Product Change Notification / JAON-17DZYV010

CCB 4560 Final Notice: Qualification of SIGN as a new assembly site for selected SST39LF80xx, SST39VF160xx and SST39VF80xx device families available in 48L TSOP (12x20mm) package.

# CCB 4560

### PCN # JAON-17DZYV010

## Pre Change LPI

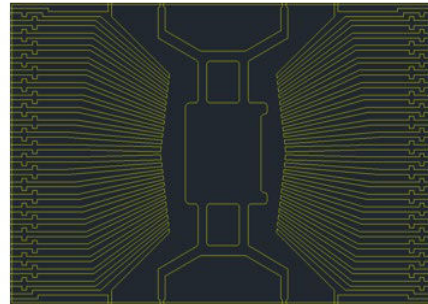
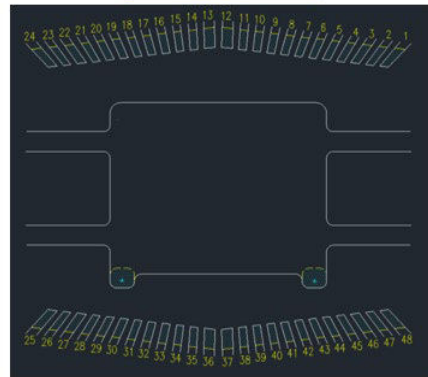
Applicable for SST39VF160xx  
device family.

## Post Change SIGN

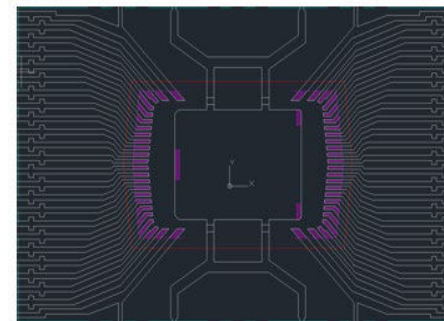
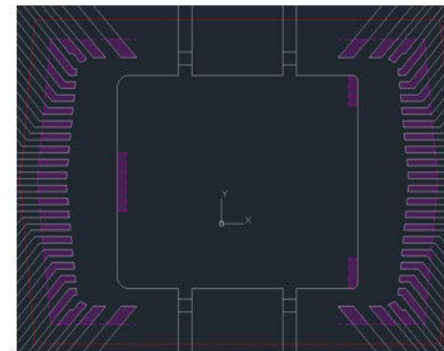
Applicable for SST39VF160xx  
device family.

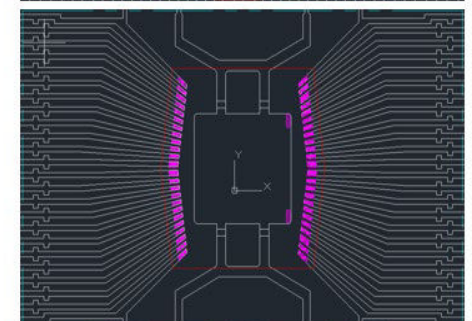
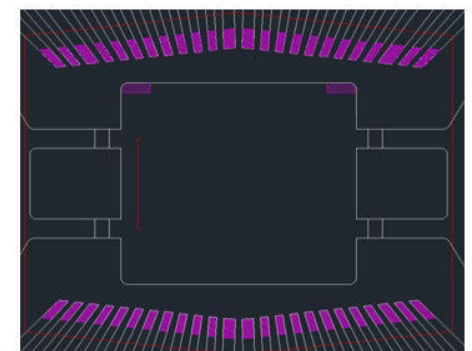
Applicable for SST39LF80xx  
and SST39VF80xx device  
families
